**CLINTON CREEK
ASBESTOS MINE
ABANDONMENT PLAN**

REVIEW REPORT

**PREPARED BY
GEO-ENGINEERING (M.S.T.) LTD.
DECEMBER 1986**

Prepared for:
Northern Affairs Program
Whitehorse, Y.T.

CLIENT NORTHERN AFFAIRS PROGRAM		CASSIAR ASBESTOS MINE	
		TITLE MINE AREA IN 1970	
SCALE 1:15000 (approx)	PROJECT No 60502	FIGURE 2.

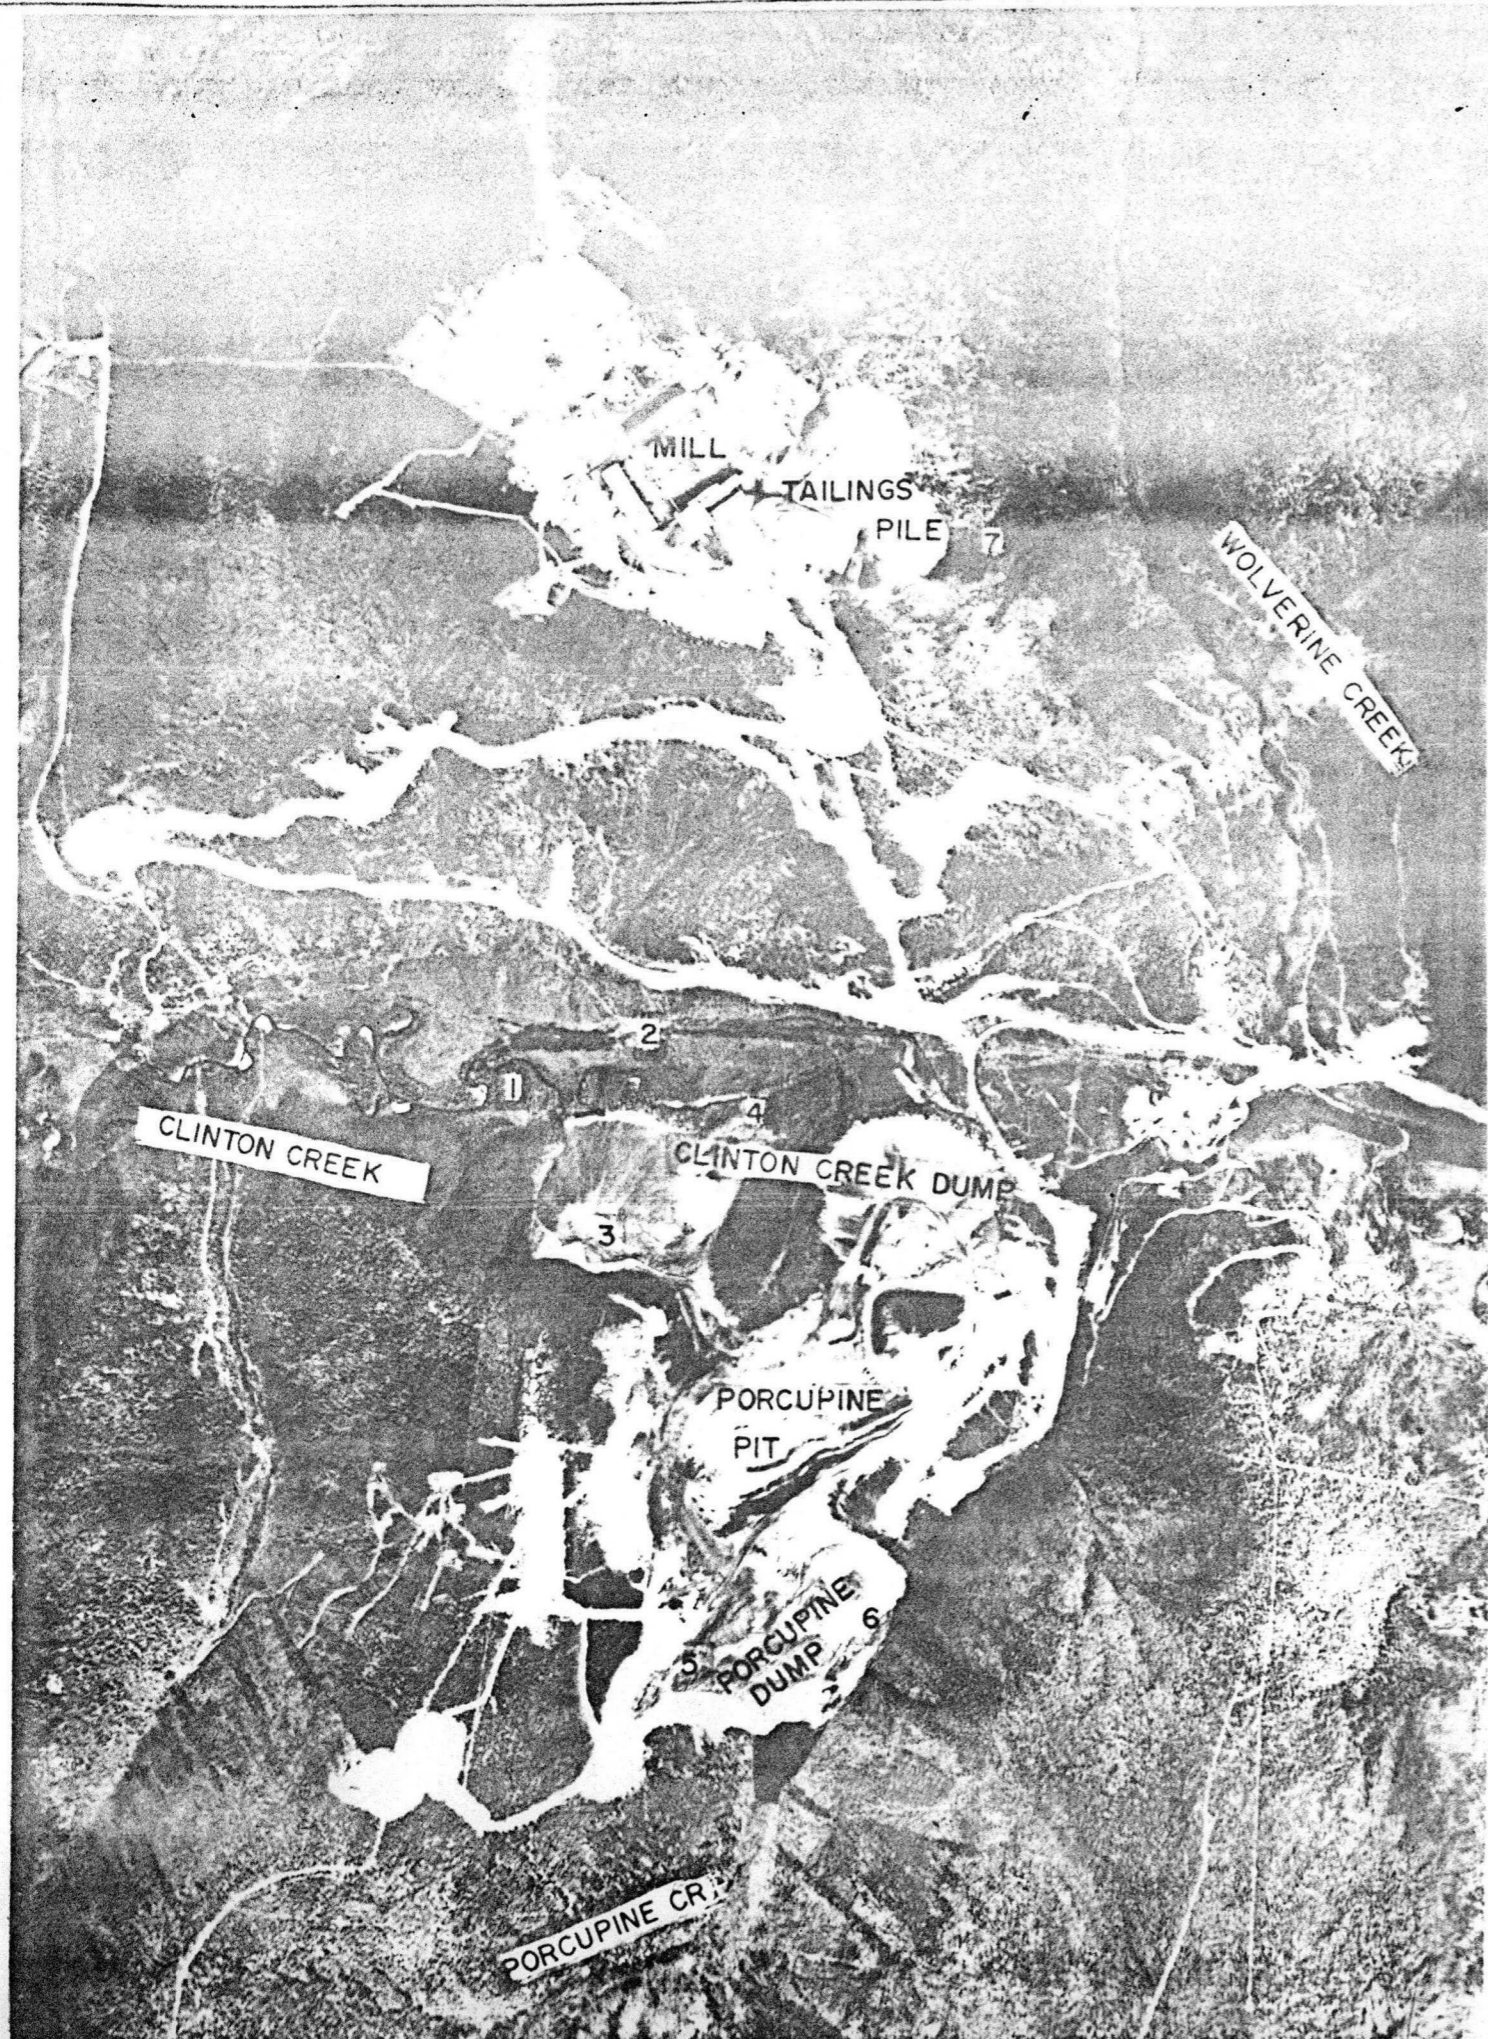
BOTH CLINTON CREEK AND PORCUPINE CREEK DUMPS WERE UNSTABLE ALREADY IN 1970.
 MAIN INSTABILITY FEATURES SHOWN ON AIRPHOTO.

CLINTON CREEK 1- ORIGINAL CHANNEL
 2- DIVERSION CHANNEL

CLINTON CREEK WASTE DUMP
 3- FISSURES ON TOP OF THE DUMP
 4- MAJOR SLIDE AND BULGING TOE

PORCUPINE DUMP
 5- FISSURES ON TOP OF THE DUMP
 6- VALLEY BLOCKAGE AND BULGING TOE

WOLVERINE CREEK TAILINGS PILE
 7- SOUTH LOBE IS BLOCKING LOCAL DRAINAGE COURSE (RAVINE) FALL AT THE BOTTOM OF THE RAVINE INDICATES PREVIOUS SEDIMENT TRANSPORT

TITLE
INSTABILITY and FOUNDATION THAWING

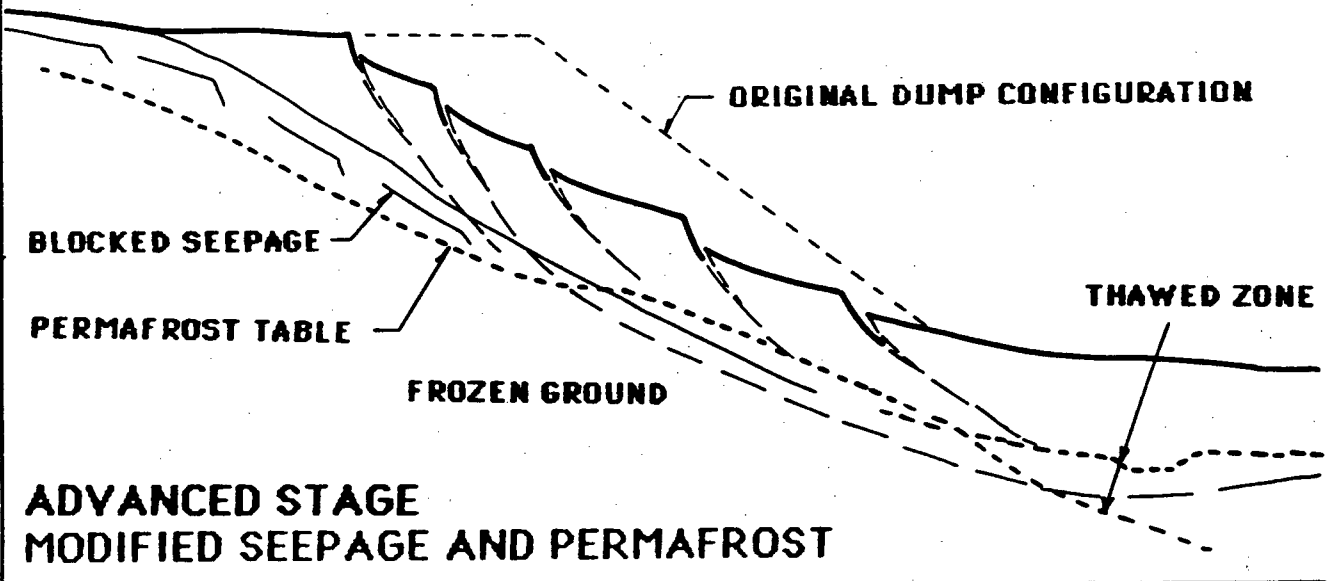
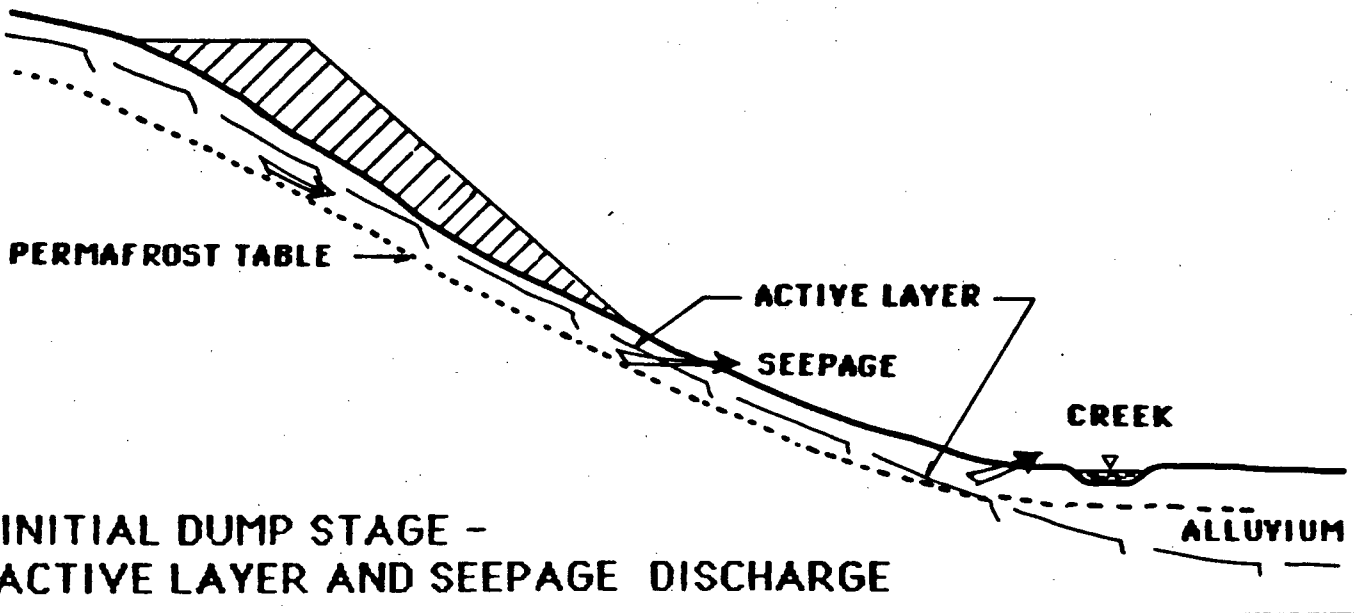
It is our opinion that the strength properties of the foundation materials, ice content and rate of thawing govern the overall stability of the embankments. The thaw-consolidation process also likely affects the pore pressure distribution. In addition, the embankment may insulate the subgrade and inhibit discharge of groundwater from the active zone during the warm season (Figure 4).

The instabilities were analyzed by Hardy (1977) and Golder (1978) and the stability of the tailings pile was also reviewed by Klohn Leonoff (1985). All these analyses indicate that a build-up of excess pore pressures in the subgrade is likely a contributing factor.

Stability analysis confirms that a Factor of Safety of unity exists for postulated slip surfaces within the foundation if a modest pore pressure exists (r_u in the range of 0.1 to 0.2). When a seismic loading of 0.1 g was applied to the analysis of the tailings pile, a Factor of Safety of below one was obtained for all tested slip planes.

TITLE **CLINTON CREEK WASTE DUMP RATES OF MOVEMENT**

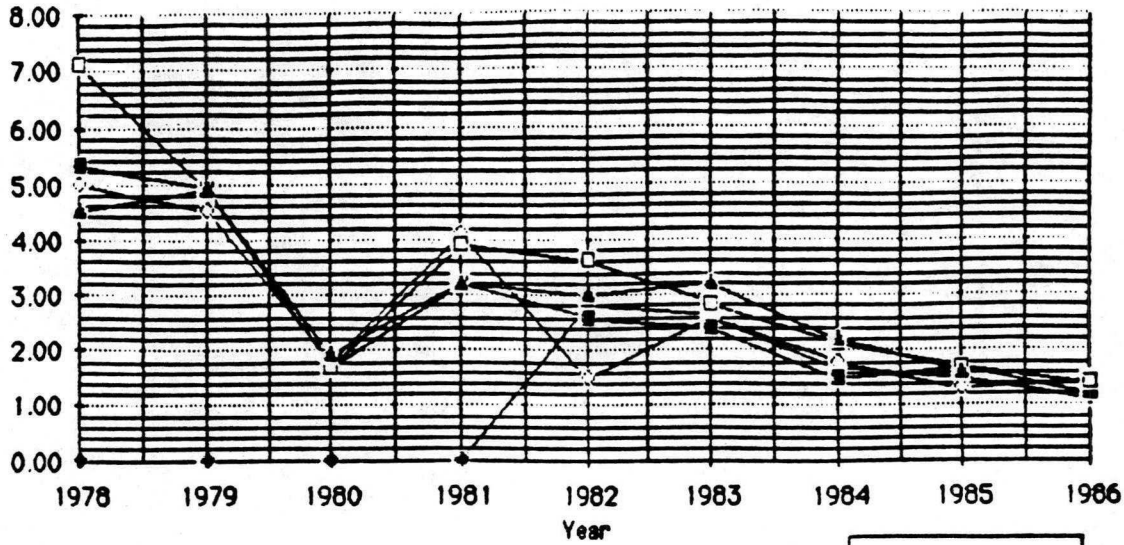
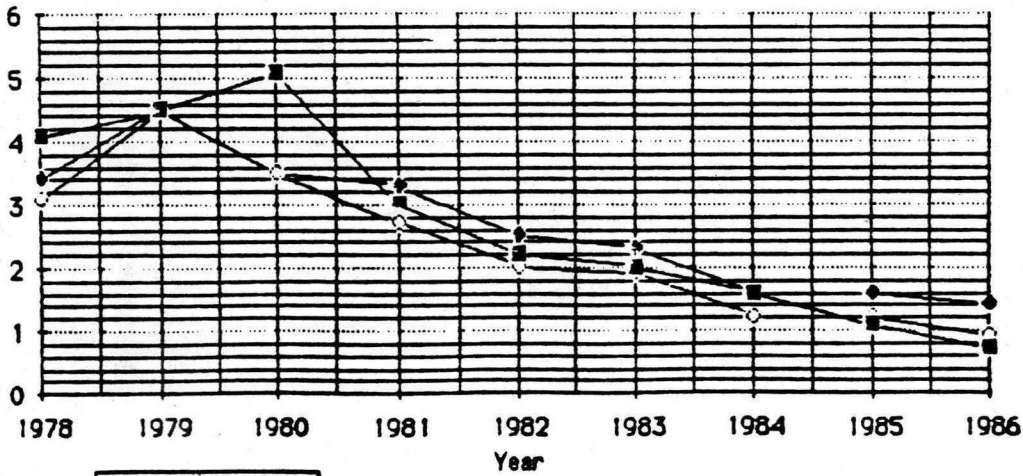
The dump movement has been monitored since 1977 by surveying monuments located on the dump surface and cross-channel reference lines. The horizontal rate of movement (Figure 5) decreased from approximately 1.2 m/year in 1978 to some 0.3 - 0.6 m/year during the 1985 and 1986 monitoring seasons.

It is not believed that the current state of the Clinton Creek waste dump ensures reasonable stability of the lake, its outlet and immediately adjacent stream channel. While a catastrophic failure of the dump is not expected, a blockage of the channel followed by erosion of slide debris could occur.

Photo 8: The rock-lined stream section (re-constructed in 1984) shows signs of erosion in 1986.

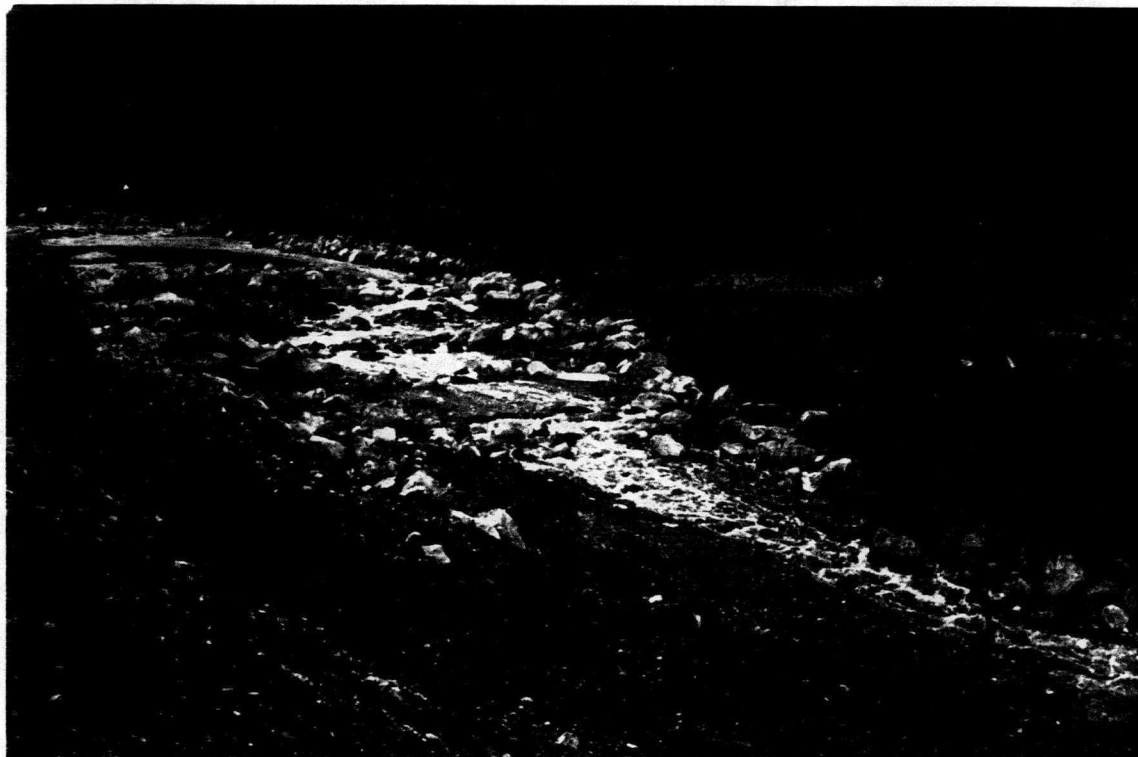
The downstream segment of the rock-lined channel shows signs of distress and the initial stages of bypassing the armoured channel. Local bed erosion (retrogressive) is apparent from the longitudinal channel profiles, surveyed in 1983, 1984 and 1986. Downcutting and oversteepening of the channel banks is also apparent.

TITLE **WOLVERINE CREEK TAILINGS PILE
RATES OF MOVEMENT**

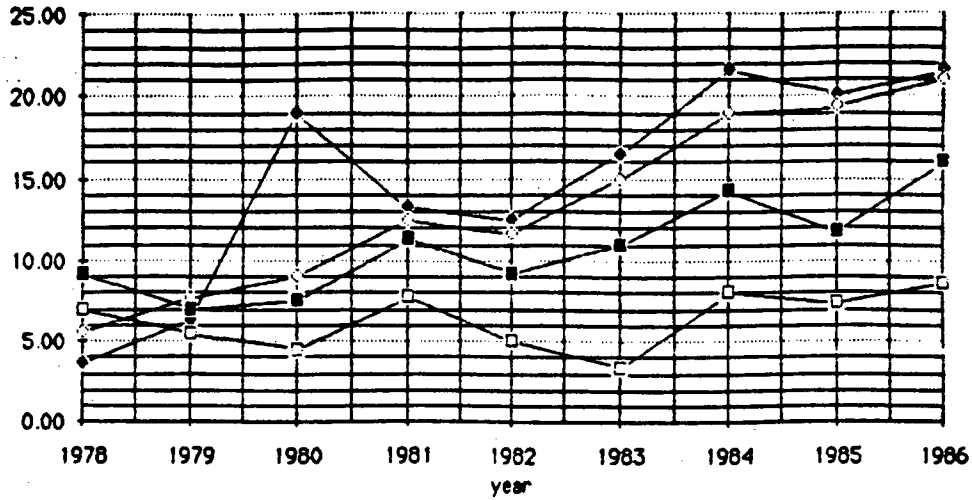
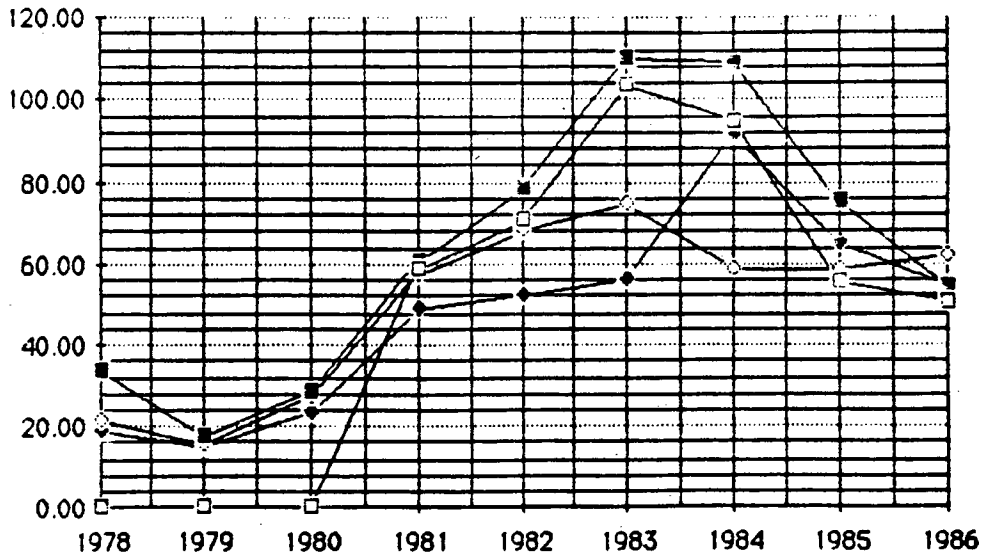
The rates of movement recorded are greater and more erratic than those of the waste dump (Figure 6). The tailings are moving in a "caterpillar-like" manner. As a lower segment fails, toe support for the section above it is removed and the failure gradually progresses up the slope with the amount of horizontal movement decreasing in the upslope direction. The toe of the dump is rising and gradually increasing the blockage of the valley bottom.

The blockage will be eventually overtopped with consequences similar to events which followed the south lobe failure in 1974. This could occur as early as during or after the 1987 spring breakup. In that case, the tailings pile toe would be eroded progressively down resulting in lowering of the lake level and flooding of the downstream valley section. Transportation as well as deposition of fine to coarse tailings particles throughout the Wolverine Creek and Clinton Creek valleys would accompany the breach of the valley blockage.

Photo 13: South lobe of the Wolverine Creek tailings pile blocked the outfall channel in June, 1986.

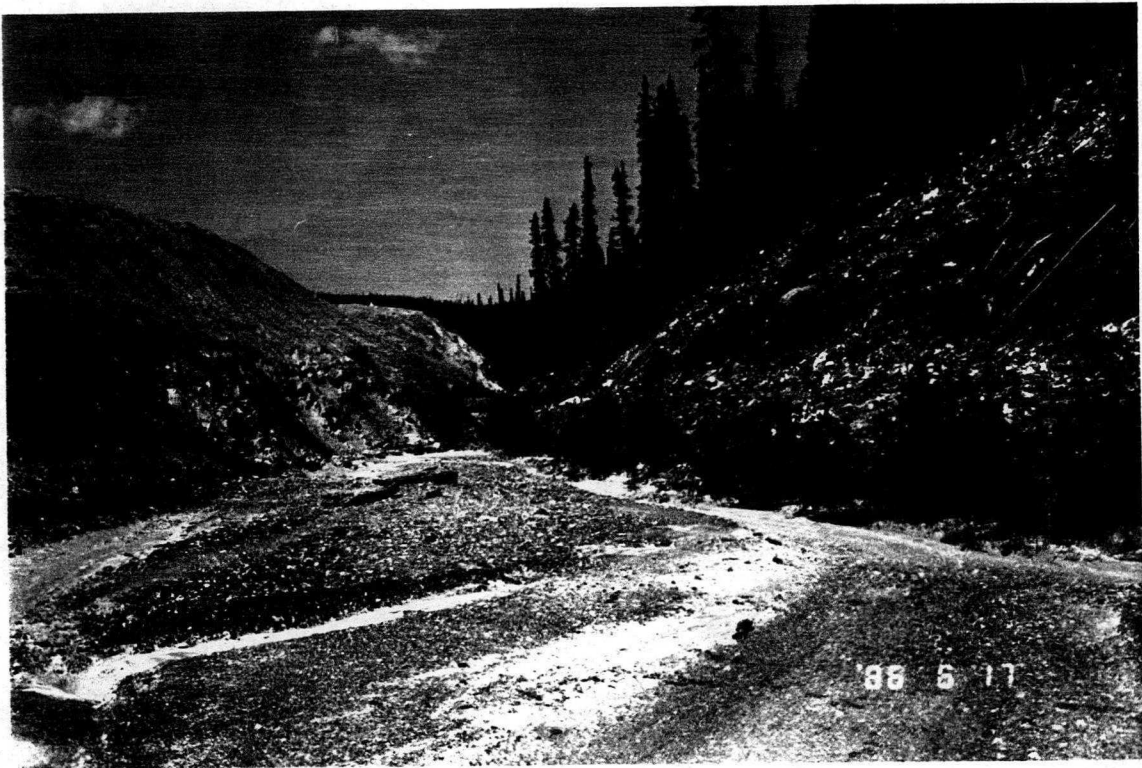
The south tailings pile lobe blocked the existing Wolverine Creek channel in 1986. There was no flow through the rock-lined channel in June, 1986 (Photo 13). The long-term stability of the rock-lined channel is questionable. It is a generally accepted practise that structures of this type require frequent monitoring and maintenance.
